London Borough of Camden
Development Management
2nd Floor,
5 Pancras Square
c/o Town Hall,
Judd St
WC1H 9JE

I am the owner of [REDACTED] I am writing to object to the planning application for [REDACTED]
[REDACTED] 75 Lawn Road (Planning reference [2018/2136/P](#)).

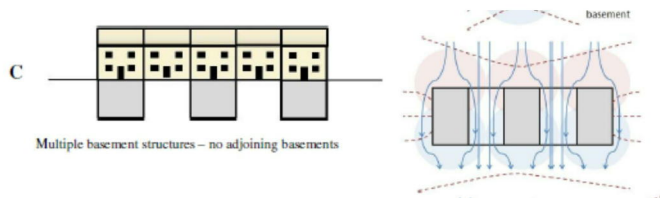
The Camden Geological, Hydrogeological and Hydrological Study raises the issue of effects of multiple basements on water flow (see Figure 1 Part C below, excerpted from one of the study’s diagrams).

I may have missed it in the 485 pages of the planning application documents but I could not see where this issue of the impact of multiple basements on waterflow had been addressed by the applicants’ advisors. My house is going to be in the position of one of the houses shown in C above i.e. increased water flow appears to be funnelled at it.

What impact will this funnelling have on my house and the land on which it sits?

What impact will the 75 Lawn Road basement have on water flows into my garden and under my house? I would like to be clearer on this in relation to the diagram above.

Figure 2: annotated excerpt from submitted plans

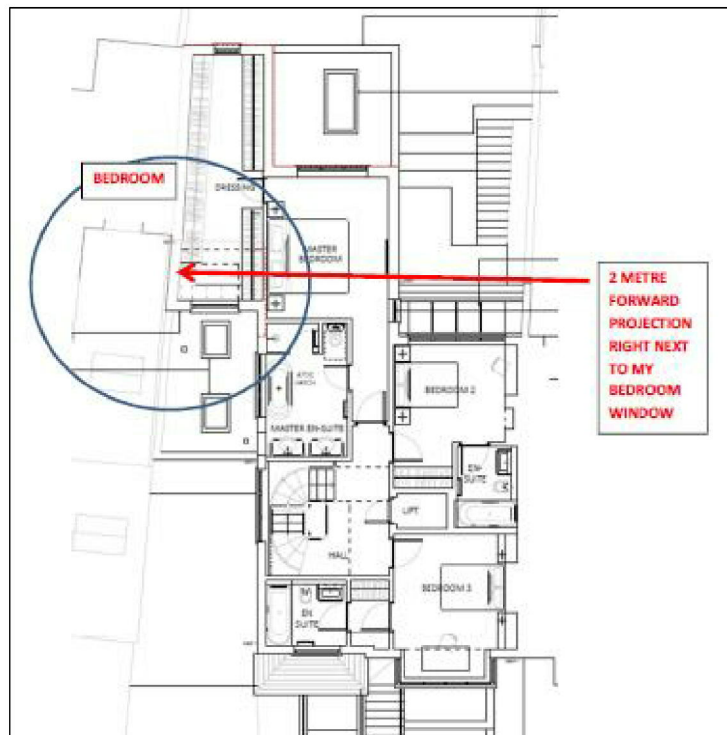
I object to the proposed 1st floor front projecting extension abutting [REDACTED]. This extension will project forward by about 2 metres along the boundary wall [REDACTED] (see Figure 2).

- Para 5.3: Camden Planning wrote: *"The first floor extension would be 2m deep incorporating a dormer window within a pitched roof and would come forward of No.76s first floor window. No.76s first floor has dual aspect windows to the first floor room and **if it's a bathroom then that is not a habitable room.** Therefore it is not considered the first floor extension would have a detrimental impact to the amenities of No.76 in regards to loss of light, overbearing, overshadowing or privacy impacts."*

The room that is referred to in this comment is not a bathroom, it is a bedroom. The fact it is dual aspect at the back is irrelevant to the way the proposed 1st floor extension at No. 75 will be over-bearing and create a sense of enclosure as [REDACTED] looking out through a tunnel effect that will 'box' [REDACTED] in. **It is not acceptable to allow a 2 metre projecting extension along a boundary right next to a bedroom window (see Figure 2).** The edge of [REDACTED] window will be just 70 cm from the new 2 metre projection. It seems particularly unnecessary for No. 75 to have this front projection because that 1st floor room is shown on the application plans as a wardrobe/dressing room.
